Product Change Notification (PCN)

PCN No: 000120

Concerning Part Name : 05HCP and 05HCP/T series

Product Type : Plugable Inductor

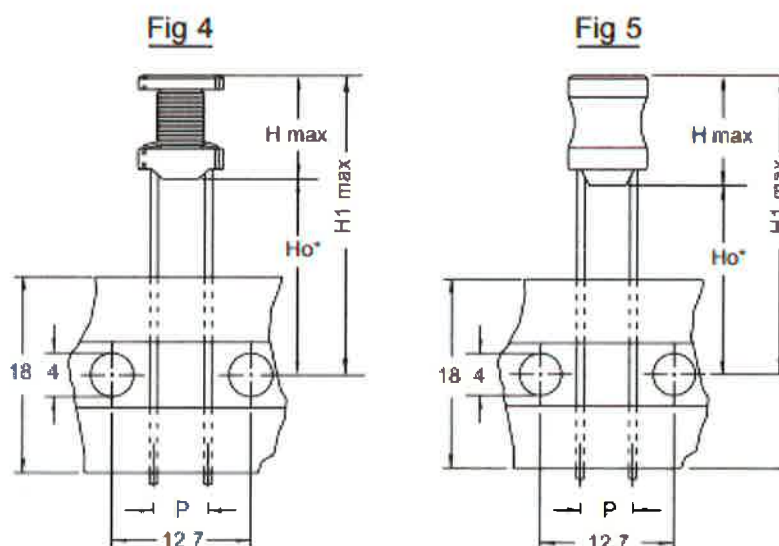
Description of Change : Revise Ho and H1 dimension (drawing) as the following:

- **Ho**: from 16mm to 18mm.
- **H1**: from 26mm max to 28.5mm max

Reason of Change : According to IEC 286 standard.
